Subject: DCA/CA response on Pleasant Prairie Solar: Native Vegetation, Wetlands, Hydrology and Bird Impacts

To: Josh Hreha, Project manager, Invenergy
From: Darby Creek Association and Columbus Audubon
Subject: Communication regarding proposed Pleasant Prairie Solar Project
Date: January 26, 2021

Response to Comments on Pleasant Prairie Solar: Native Vegetation, Wetlands, Hydrology and Bird Impacts

Case No(s). 20-1679-EL-BGN

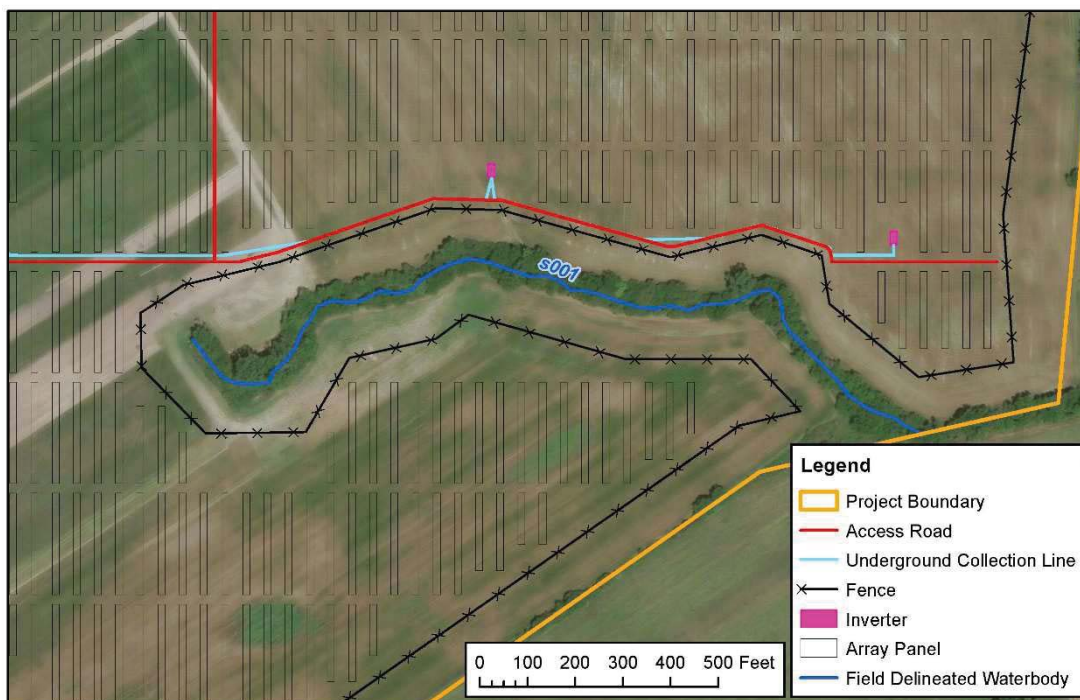
- 1) Wetlands: The facility should ensure adequate protection of wetlands, starting with a complete and proper Inventory and delineation of all wetlands, including temporary wetlands (Category I), and adequately protective buffers, adequate protection of wetland hydrology, preservation and enhancement of wetland wildlife, and connection to conservation land. We understand that as part of Clean Water Act obligations the facility will need to produce wetland identification, delineations and wetland scoring for the Army Corps of Engineers and Ohio EPA. We expect to have other protection points to follow. We expect that wetland impacts will be avoided to the greatest extent practicable, and that significant wetland enhancement might be possible, especially given the proximity to Battelle-Darby Metro Park.

As part of our site evaluation, the Project team conducted a detailed survey of surface waters (wetland and waterbody delineations) within the Project Area in fall of 2020. This Report was provided as part of our Application to OPSB, see Exhibit C - part 5 of 25.

This report provides details on delineated features including their scoring on the ORAM or HHEI/QHEI assessment forms. A total of 15 wetlands and one pond were delineated during field surveys, for a total of 8.15 acres of wetlands within the Project Area. Eleven of these wetlands were categorized as emergent, three were categorized as forested, and one was categorized as shrub-scrub. One wetland (W-002) was categorized as potentially jurisdictional and scored as lower quality wetlands on the ORAM. No wetland crossings are proposed, and we anticipate no impacts to wetlands from the construction or operation of the Project based on our current design.

The Project has also developed a Landscape and Vegetation Management Plan (Exhibit E to the Certificate Application), that provides details on stabilization, and the planting of native, low-growing, herbaceous vegetation. This land cover will provide a greater diversity of species and will be maintained year-round, as opposed to seasonal disturbance of crop harvest, providing continuous ground covering and stabilization. This maintained ground cover will reduce runoff and sedimentation to local waterbodies in comparison to an agricultural field. As well as act as a vegetated buffer around the existing wetlands.
